CITY PLAN COMMISSION REPORT

Mazuma Credit Union on North Oak

#4 CD-CPC-2020-00191
Rezoning to MPD

Plan Conditions, Corrections, & Recommendations Report

3 EAST ELEVATION
A-3.1 | A-6.1 SCALE: 1/4" = 1'-0"

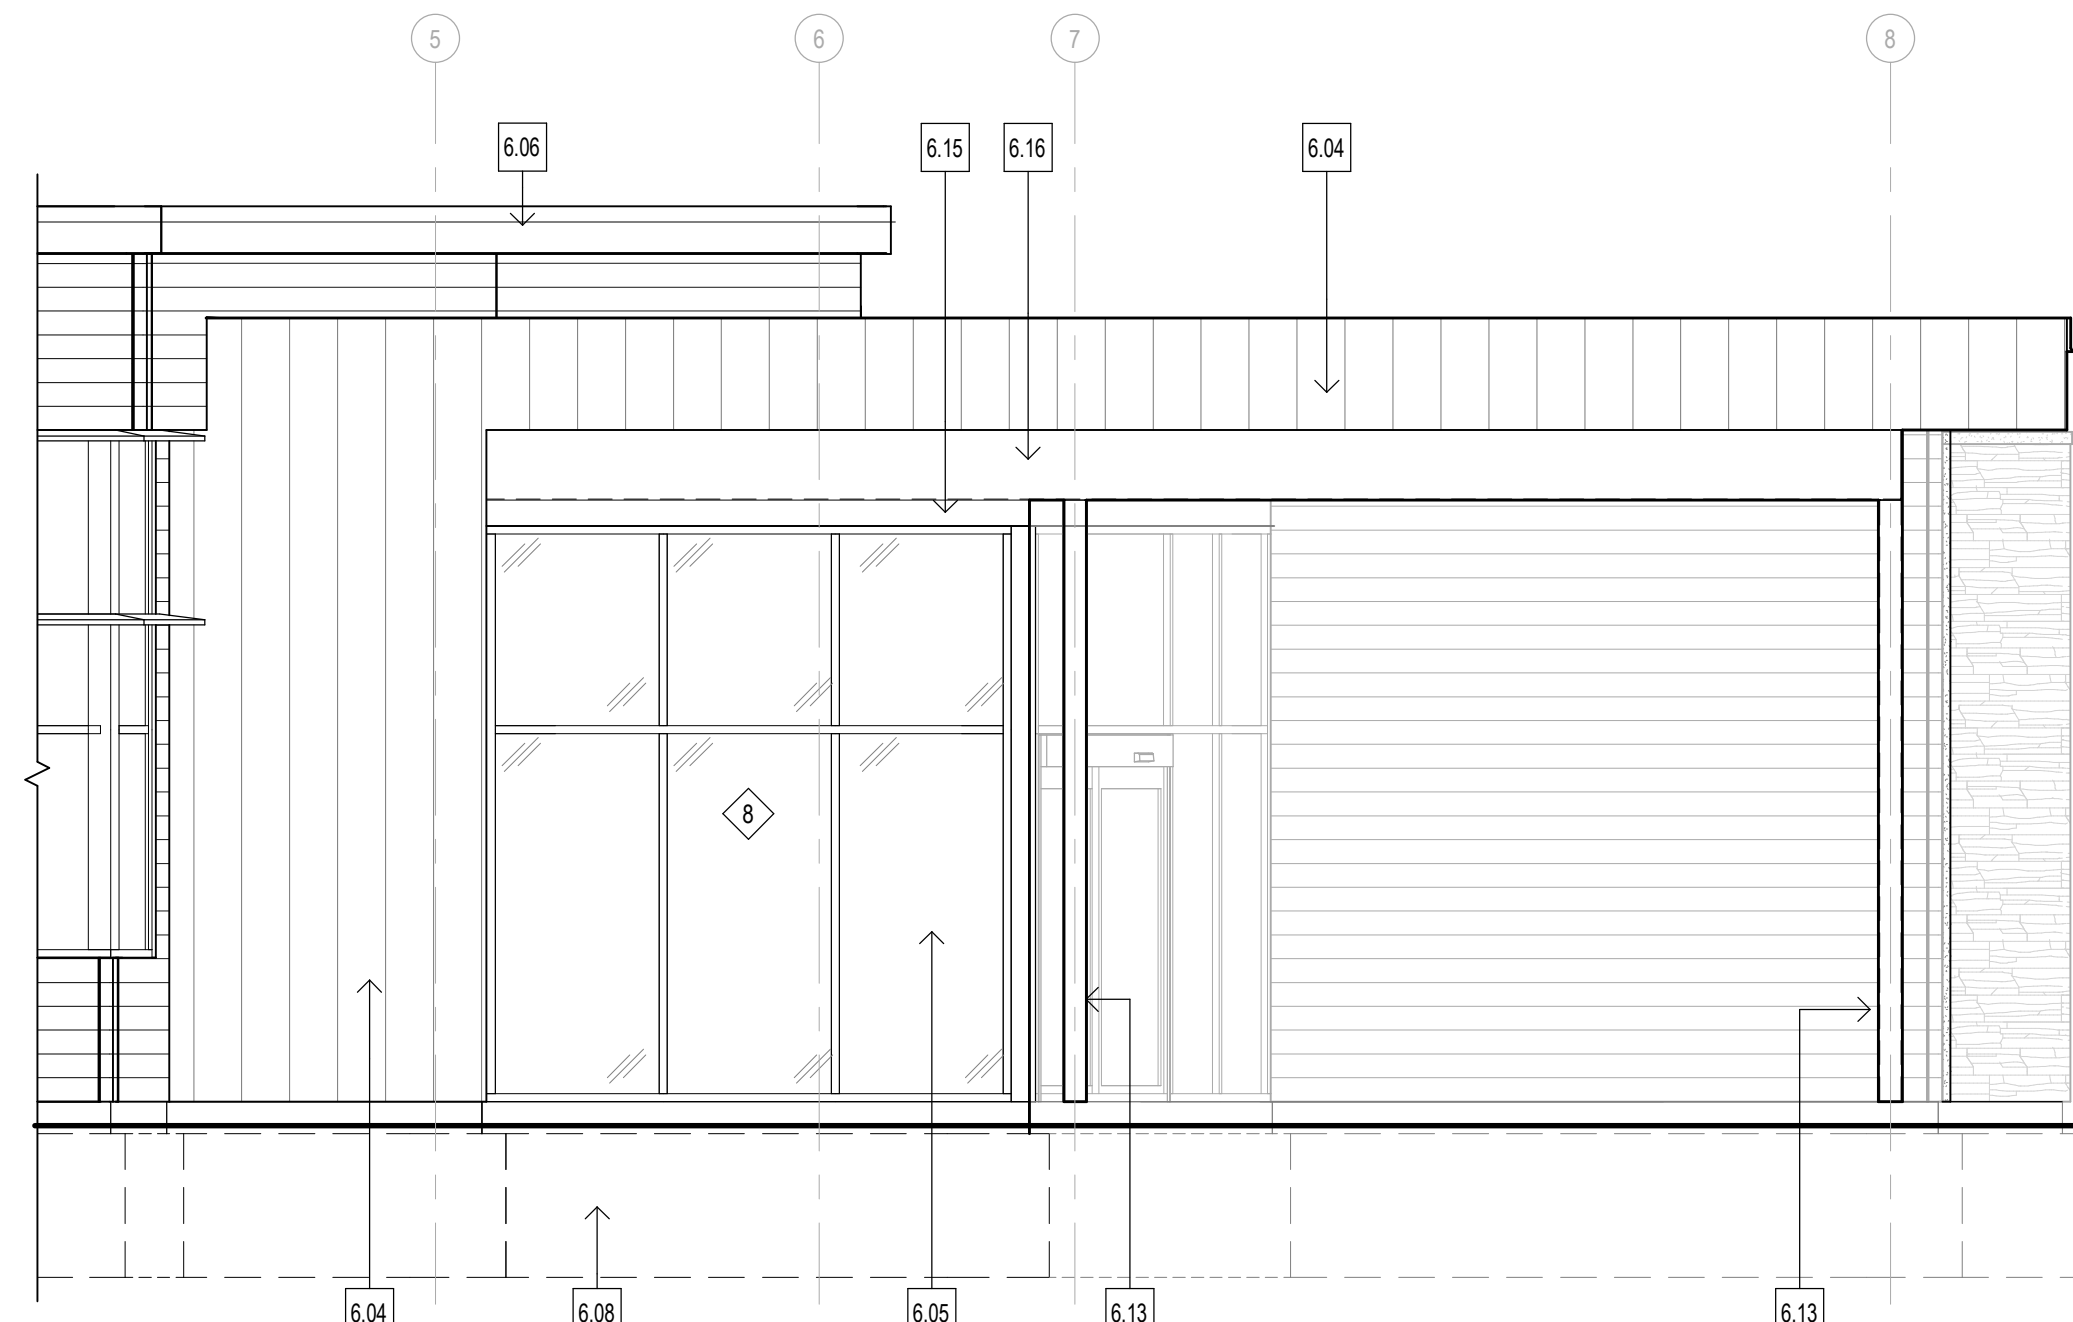
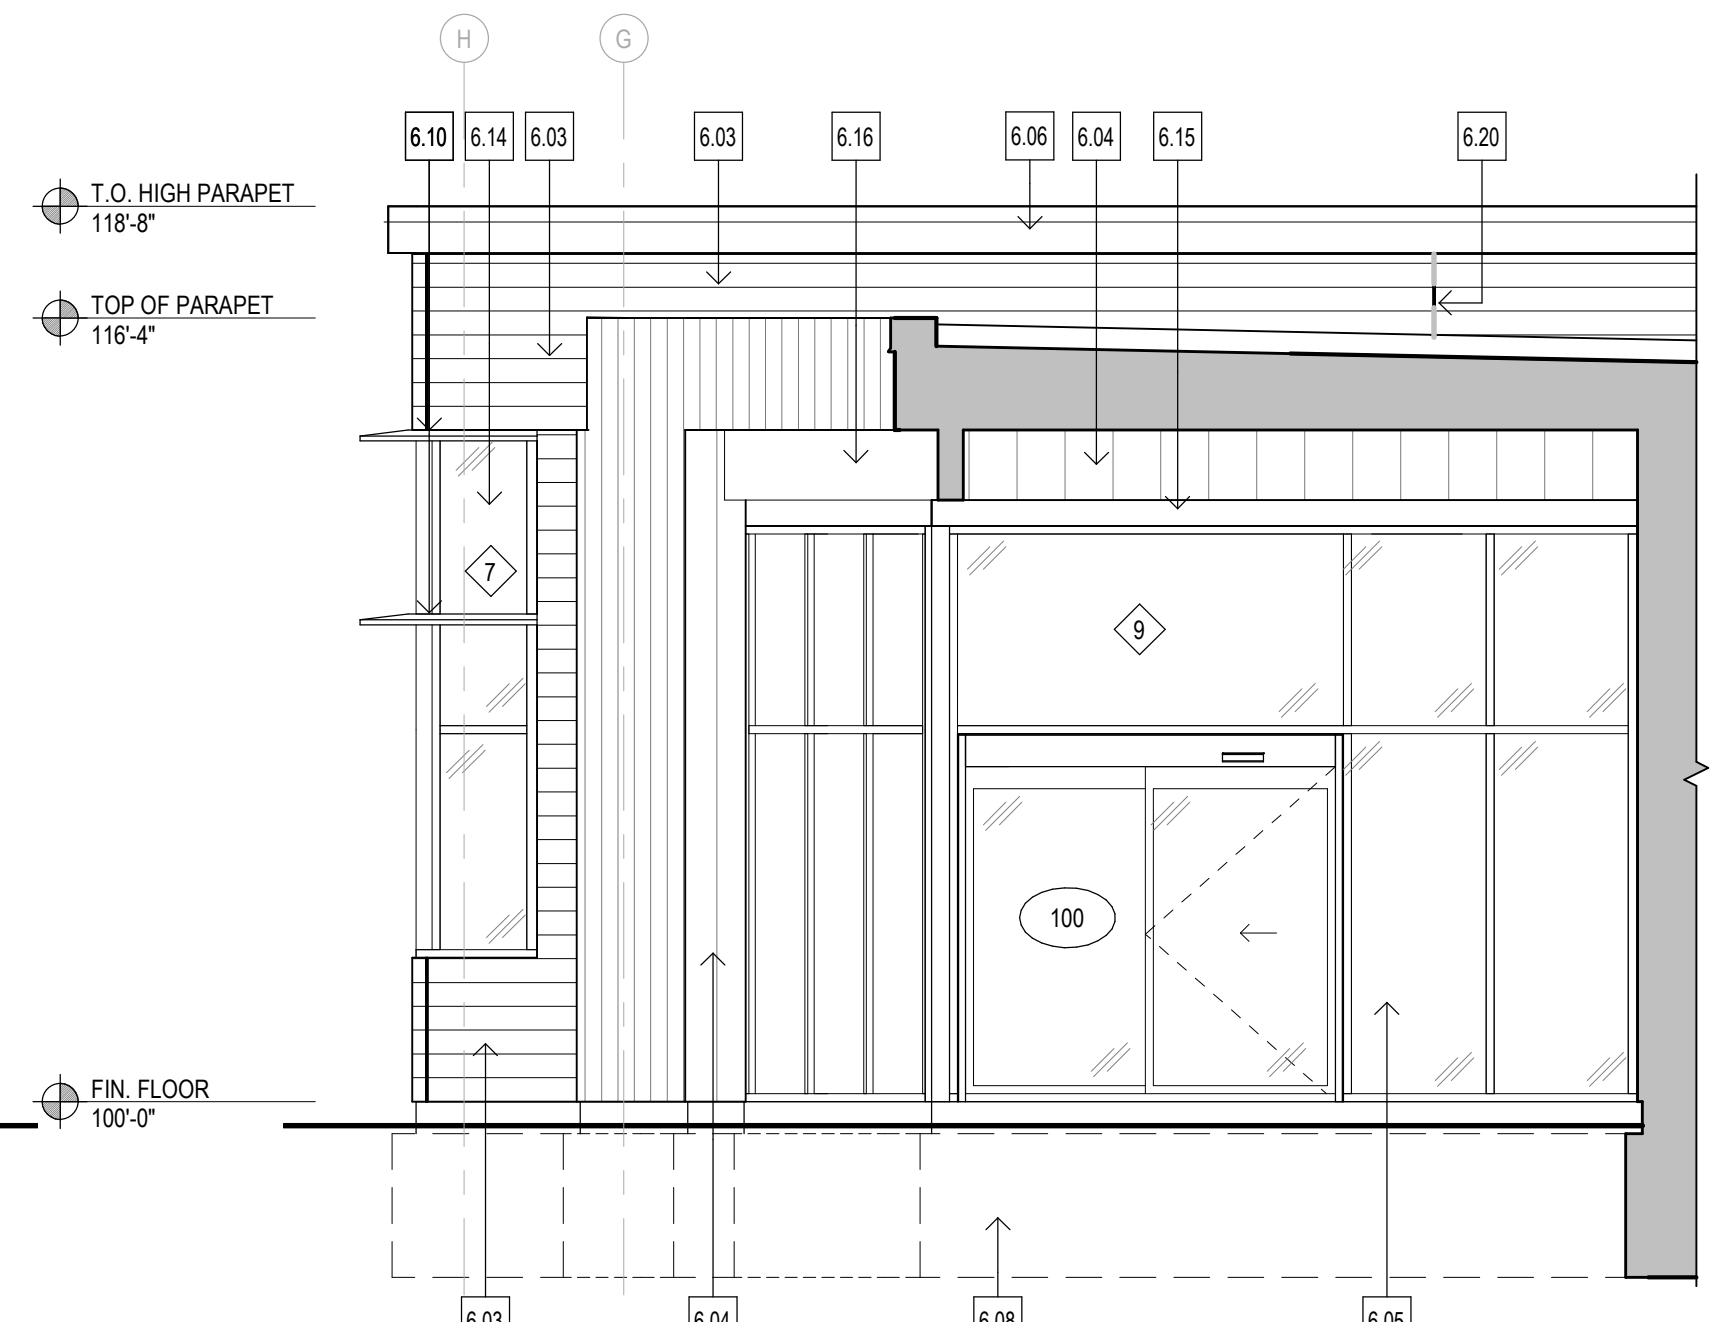
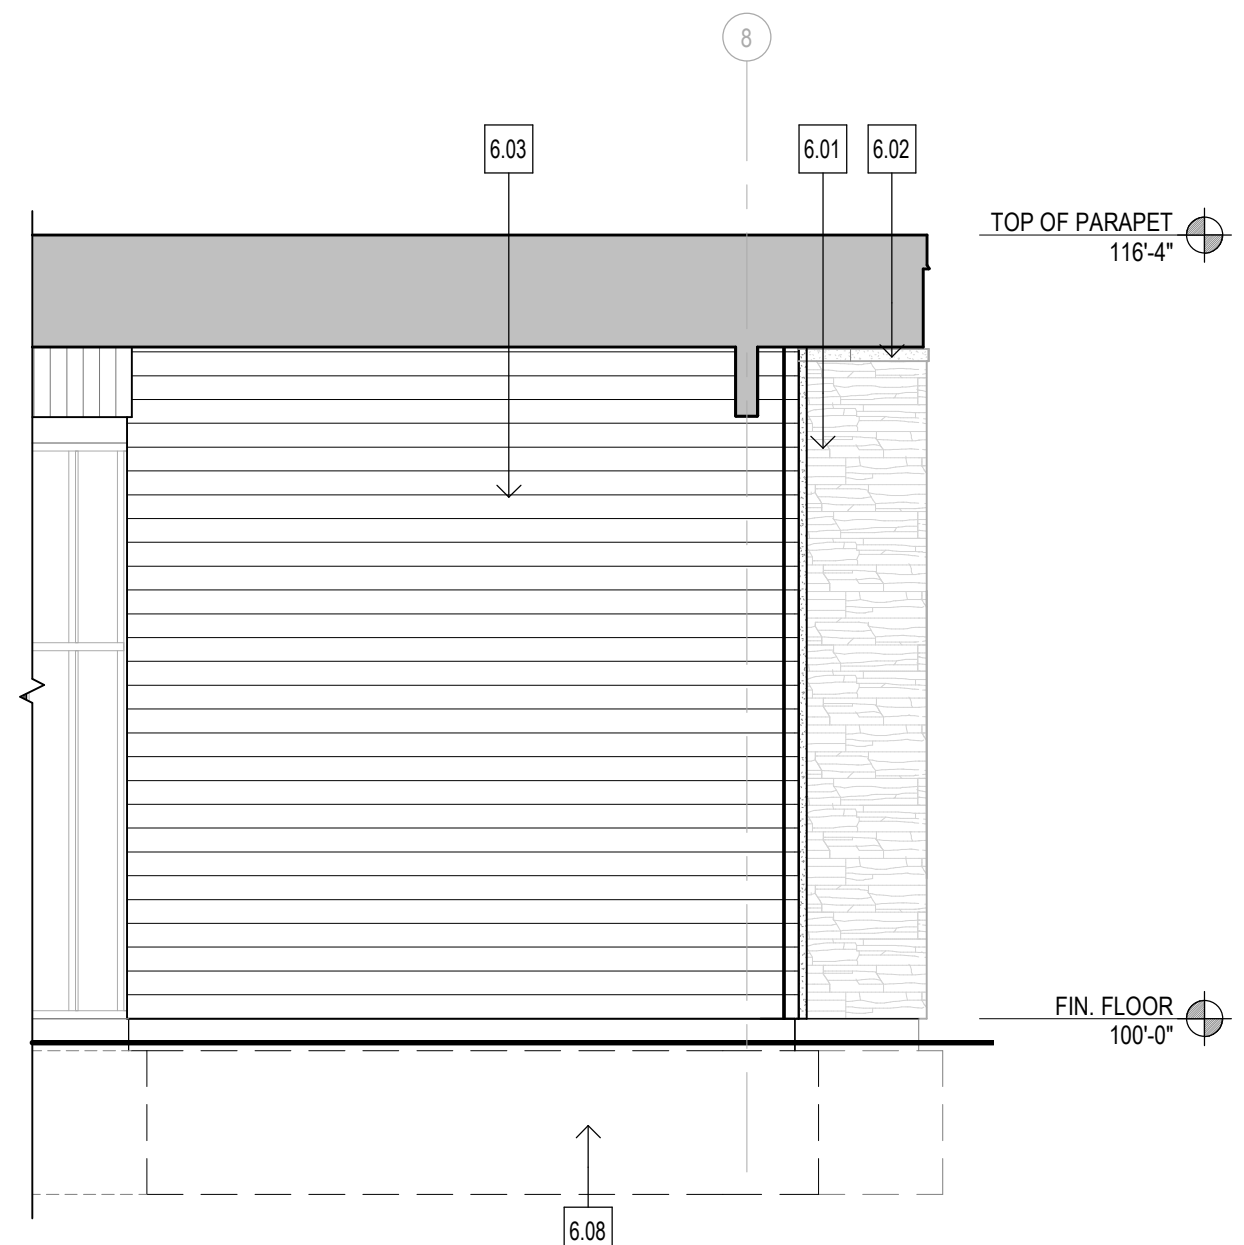
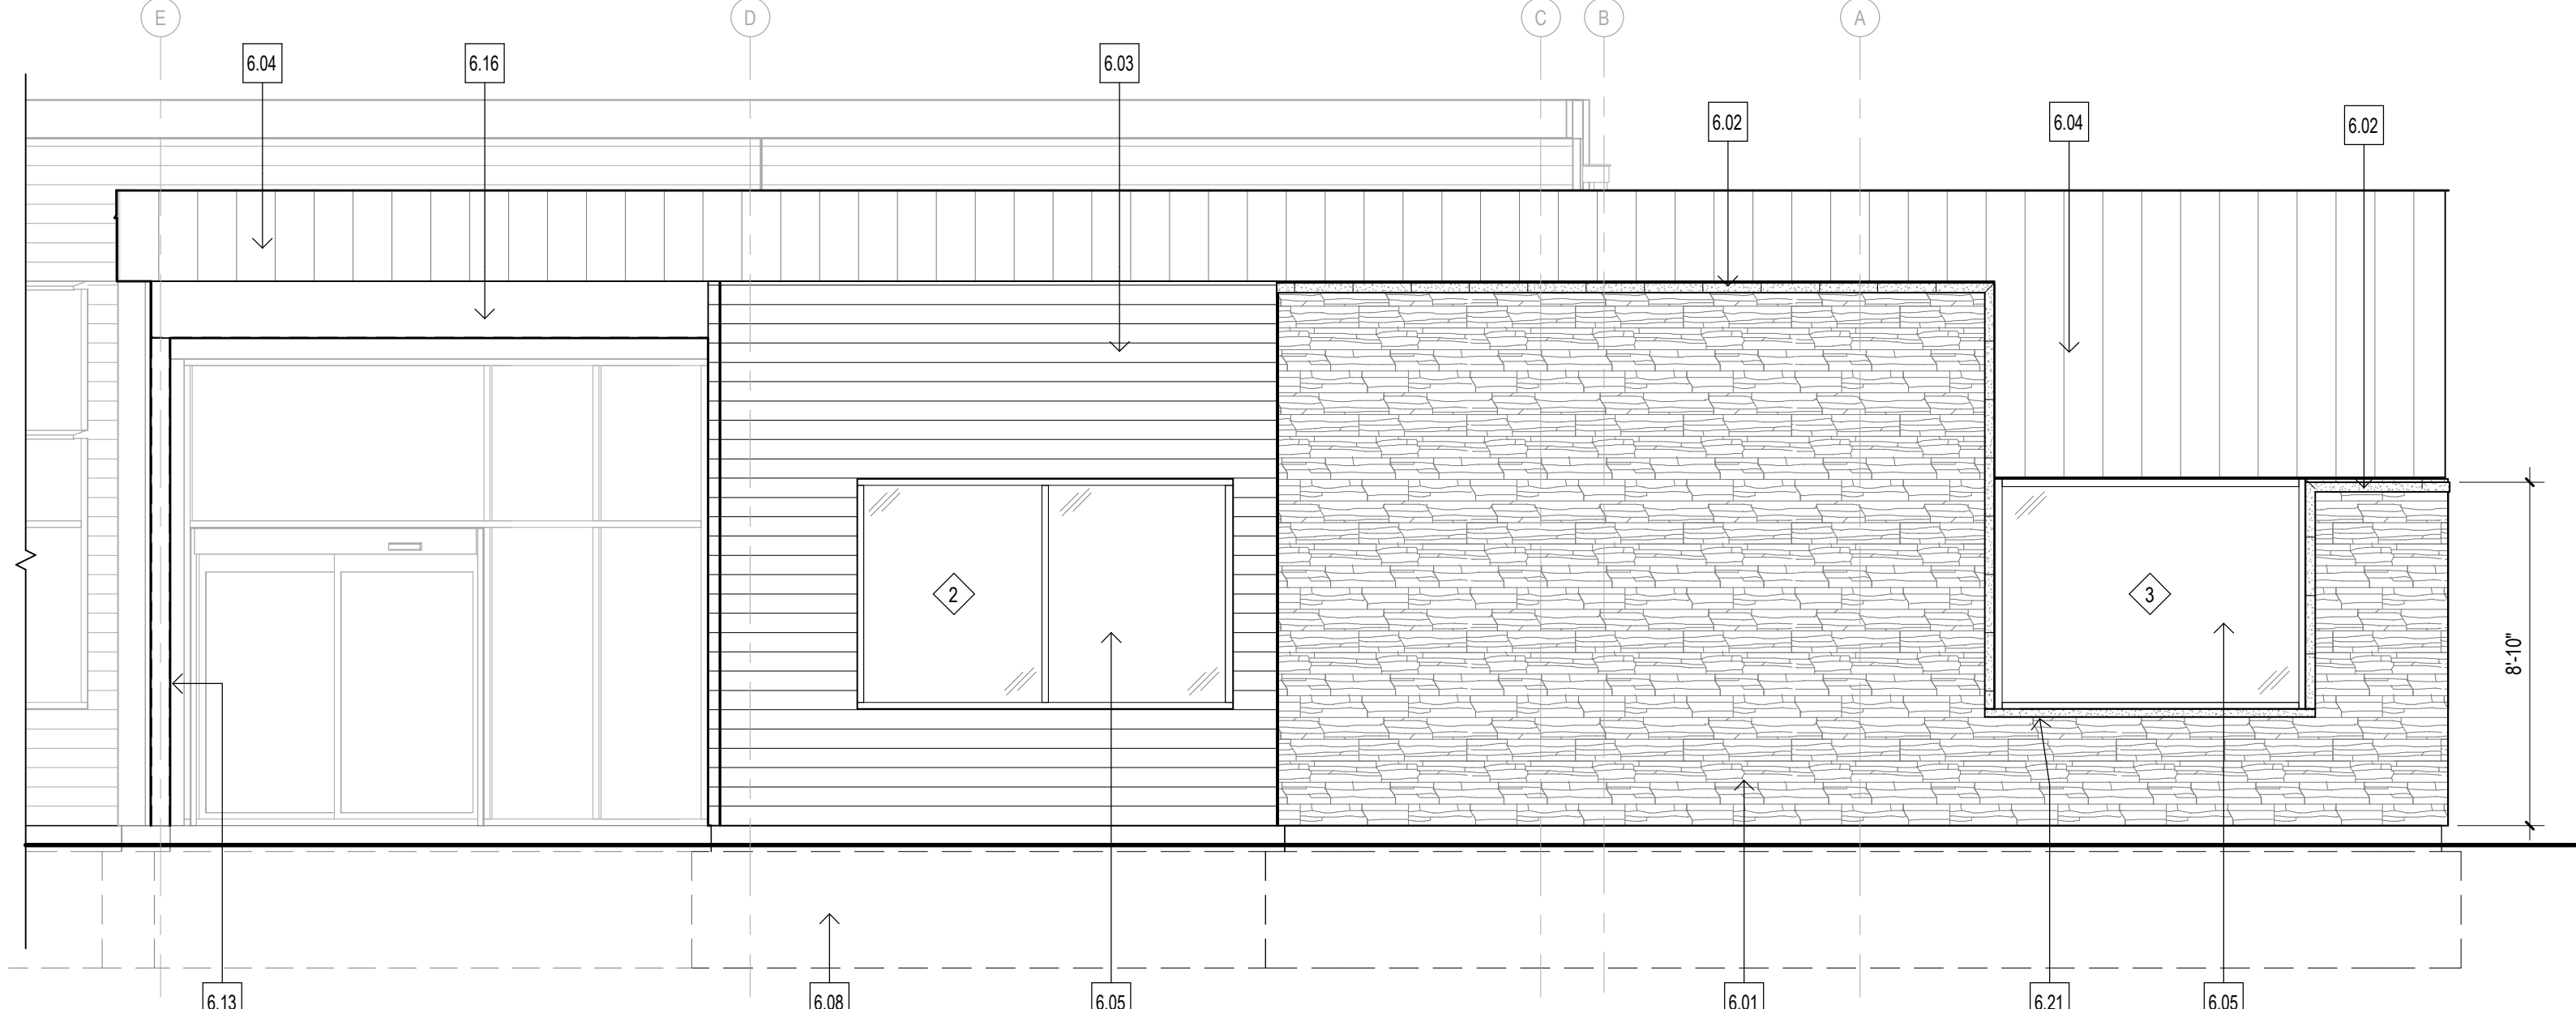
The building elevations include appropriate use of stone, wood, and metal panel accents; however, staff has not received complete drive-through designs and will need such to ensure compliance with the standards of 88-340.
